| Project                      | <b>IEEE 802.16 Broadband Wireless Access Working Group</b> < <a href="http://ieee802.org/16">http://ieee802.org/16</a> >  |   |
| Title                        | <b>Modification of Sleep mode SDL</b>   |   |
| Re:                          | This is a response to a Call for comments about IEEE802.16e-D3  |   |
| Abstract                     | The document contains suggestions on modification of Sleep mode SDL   |   |

Figure 130d – Typical MSS Listening SDL diagram

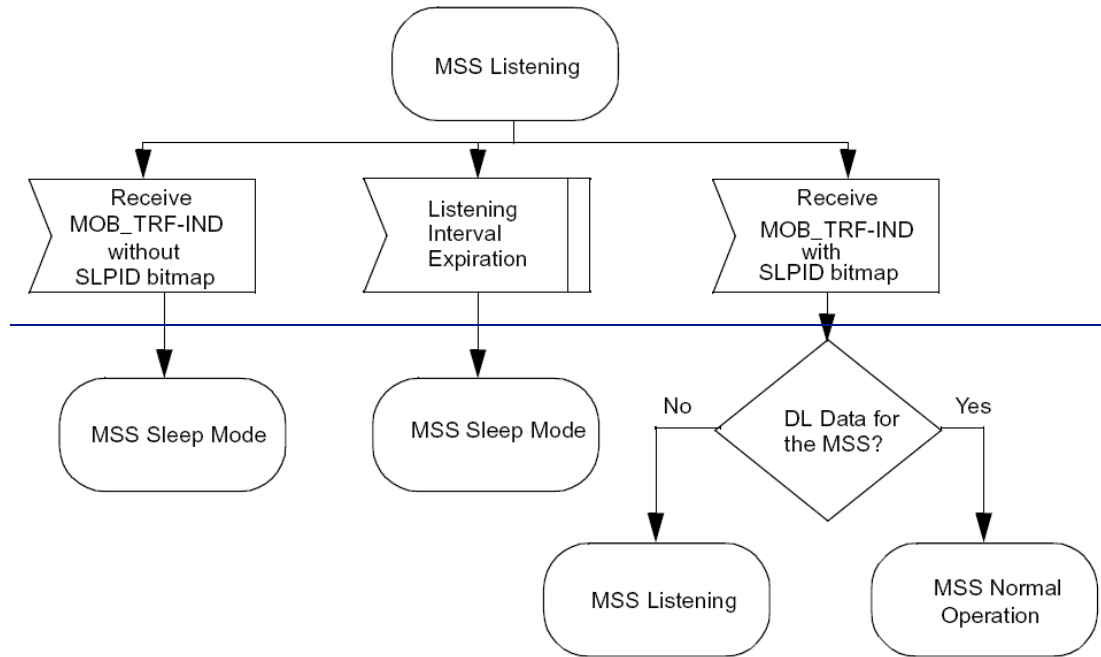
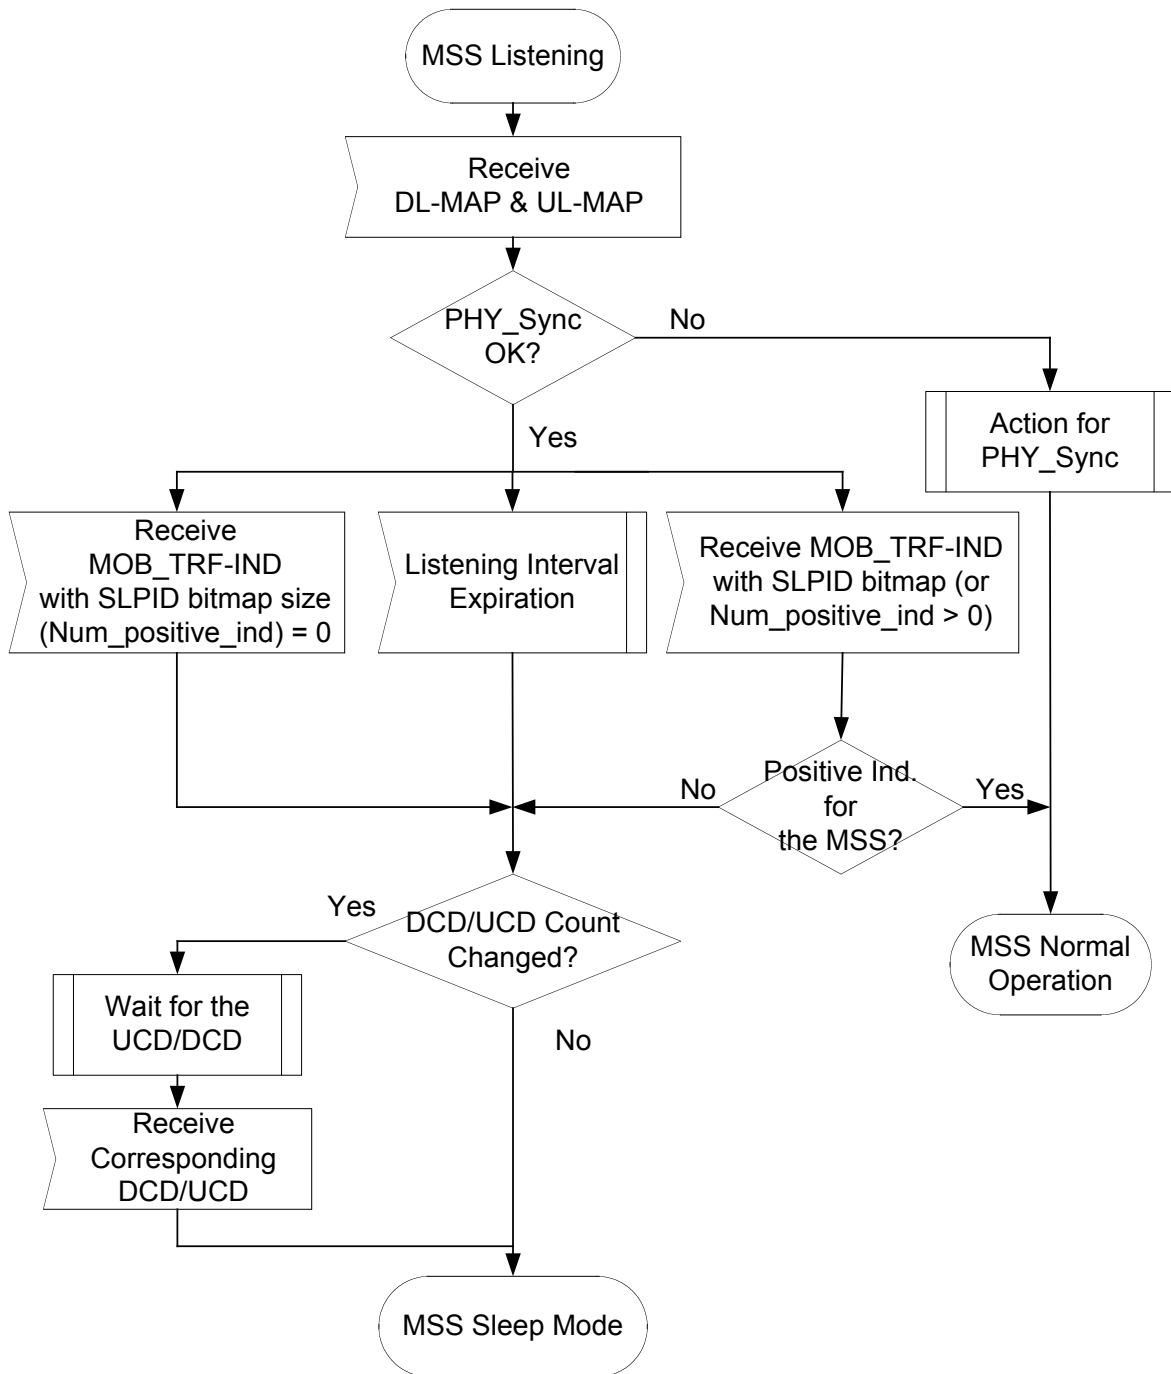
*[Change Figure 130d –Typical MSS Listening SDL diagram from:]*

[to:]

Figure 130g – BS-MSS Sleep Mode SDL Diagram

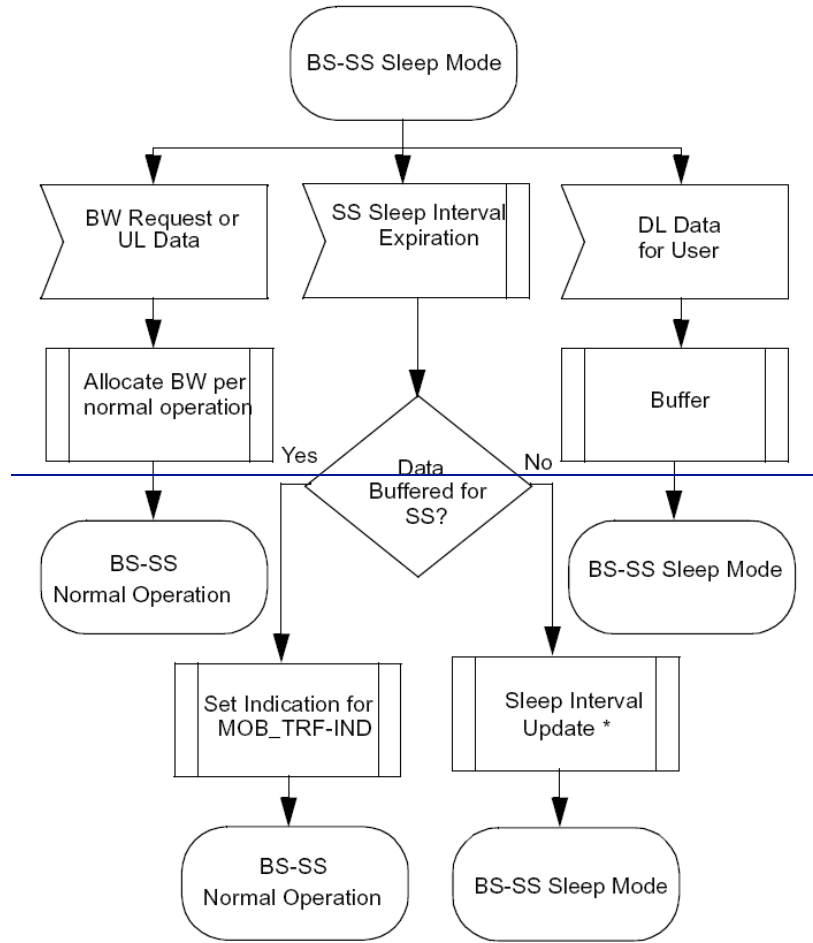
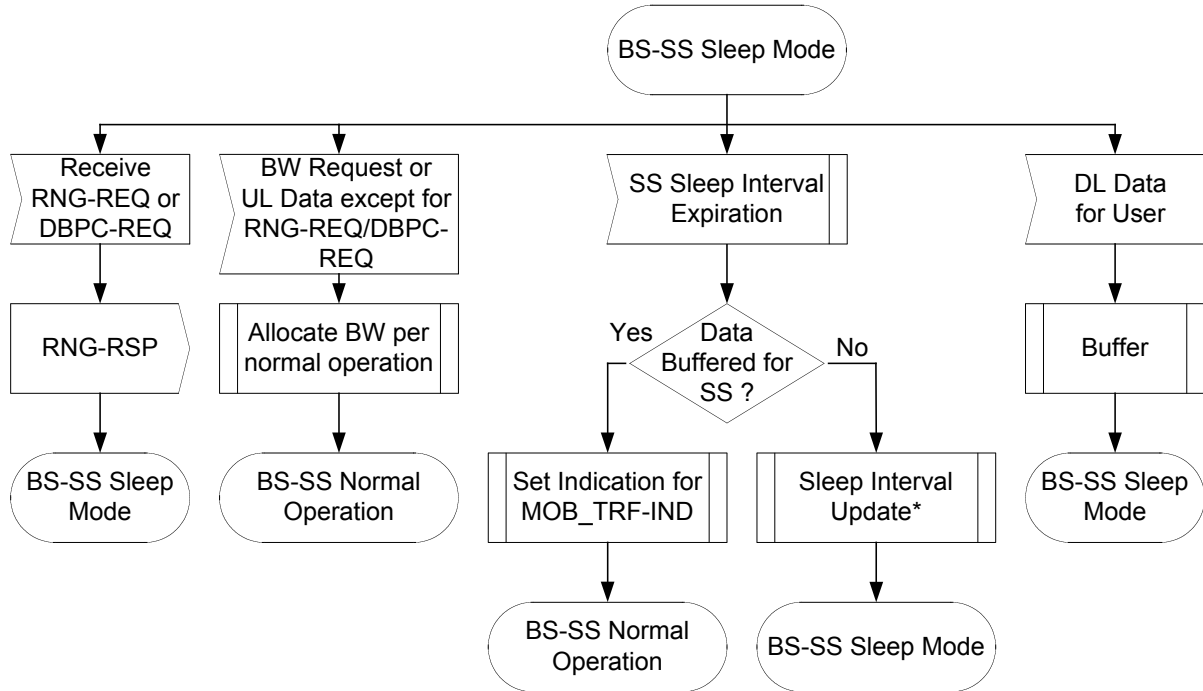
[Appropriately Change the Figure 130g from:]

[to:]
